**Validation report form for post-registration changes for
CDM project activities
(Version 03.0)**

Title and UNFCCC reference number of the project activity	<ul style="list-style-type: none"> Title: KDHC Daegu Biomass Cogeneration Project Reference number: 5153
Process track	<input type="checkbox"/> Prior approval <input checked="" type="checkbox"/> Issuance <input type="checkbox"/> Renewal of crediting period
Version number of the validation report	<ul style="list-style-type: none"> Version 1.2
Completion date of the validation report	<ul style="list-style-type: none"> 14/05/2021
Type(s) of PRCs	<input type="checkbox"/> Temporary deviations from the registered monitoring plan, applied methodologies, standardized baselines or other methodological regulatory documents ¹ <input type="checkbox"/> Corrections <input type="checkbox"/> Changes to the start date of the crediting period <input type="checkbox"/> Inclusion of a monitoring plan <input checked="" type="checkbox"/> Permanent changes to the registered monitoring plan, or permanent deviation of monitoring from the applied methodologies, standardized baselines or other methodological regulatory documents <input checked="" type="c

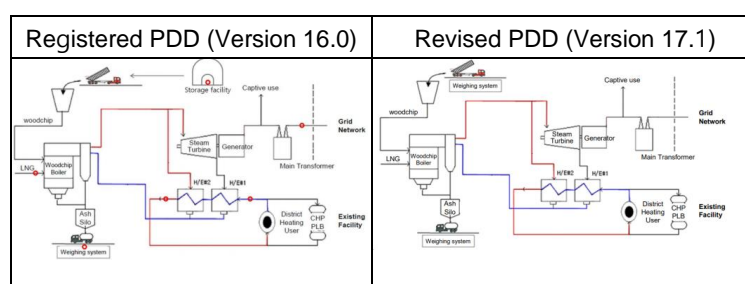
- EG_{storage,y}: imported electricity in the woodchip storage site
- FF_{storage,y}: consumed diesel of heavy equipment in the storage site

And measurement methods and procedures are changed as follows:

- TL_{woodchip,y}:
“(Calculated at the storage site and the CHP site. The lower value is applied)” is excluded.
- MAD_{woodchip}: “the distance between project site and Geoje via the storage site(175km) is applied” is changed as “the distance between project site and Geoje (165km) is applied”
